MIL-S-19500/99E
AMENDMENT 2
15 July 1986
SUPERSEDING
AMENDMENT 1
25 September 1967

MILITARY SPECIFICATION

SEMICONDUCTOR DEVICE, TRANSISTOR, NPN,
SILICON, SWITCHING, MEDIUM-POWER
TYPES 2N696, 2N697, 2N696S and 2N697S

This amendment forms a part of MIL-S-19500/99E, dated 31 July 1967, and is approved for use by all Departments and Agencies of the Department of Defense.

FIGURE 1. Physical dimensions.

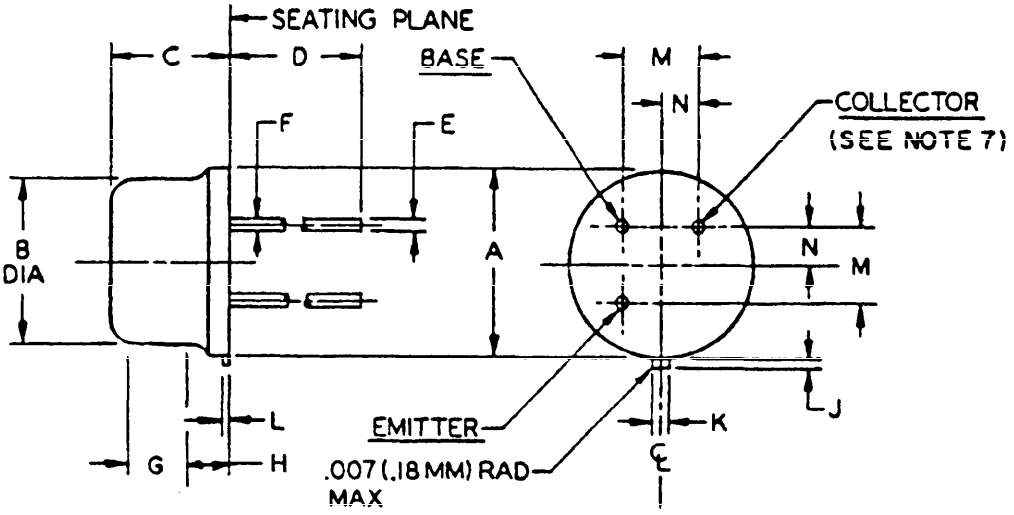
* FIGURE 1: Delete and substitute new figure 1 as printed on page 2 of this amendment.

* 10. For transistor types 2N696S and 2N697S, D is .500 (12.70 mm) minimum, and .750 (19.05 mm) maximum.
* 11. For transistor types 2N696 and 2N697, D is 1.500 (38.10 mm) minimum, and 1.750 (44.45 mm) maximum.
